# Access Compliance Report

## Public Rights-of-Way

### (Curb Ramps)

Intersection ID: 11265	Main Street: N_TRYON_ST	Cross Street: WADSWORTH_PL	Location: E
ADA ID: 8E04A81EA762	Ramp Type: Directional1	Initial Pass/Fail: Fail	Overall Compliance: No
		Severity Score: 12.5

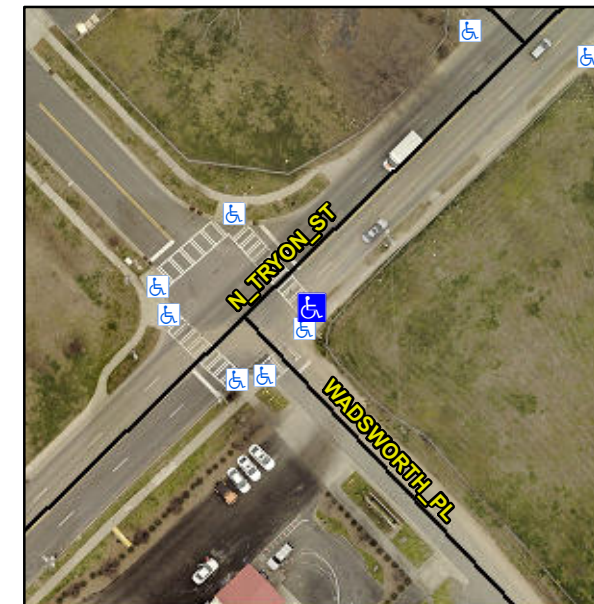
**R304.2.2**

Compliance	Description	Data	Compliance	Description	Data
N/A	Ramp Length (in)	25.0	N/A	Grade Break?	N/A
Yes	Ramp Width (in)	58.0	N/A	Grade Break Slope (%)	0.0
No	Ramp Slope (%)	10.4	N/A	Grade Break XSlope (%)	0.0
Yes	Ramp XSlope (%)	0.4			
N/A	Flare Type LT	N/A	N/A	Flare Type RT	N/A
N/A	Flare Slope LT (%)	N/A	N/A	Flare Slope RT (%)	0.0
N/A	Flare Traversable LT?	N/A	N/A	Flare Traversable RT?	N/A
N/A	Landing Length (in)	0.0	N/A	DWS Provided?	N/A
N/A	Landing Width (in)	0.0	N/A	DWS Contrast?	N/A
N/A	Landing Slope (%)	0.0	N/A	DWS Length (in)	N/A
N/A	Landing X Slope (%)	0.0	N/A	DWS Full Width?	N/A
N/A	Landing Curb? (Y/N)	N/A	N/A	DWS Offset LT (in)	N/A
N/A	Shared Landing?	N/A	N/A	DWS Offset RT (in)	N/A
N/A	Gutter Ponding?	Yes	N/A	Gutter Slope (%)	N/A
N/A	Gutter Lip Ht (in)	0.0	N/A	Gutter X Slope (%)	N/A
N/A	Painted X Walk1?	Yes		Road Slope (%)	4.4
	X Walk 1 Direction	To NW		Road X Slope (%)	1.0
	X Walk 1 Width (in)	117.5		Clear Space?	N/A

**Remove & Replace Entire Ramp.**
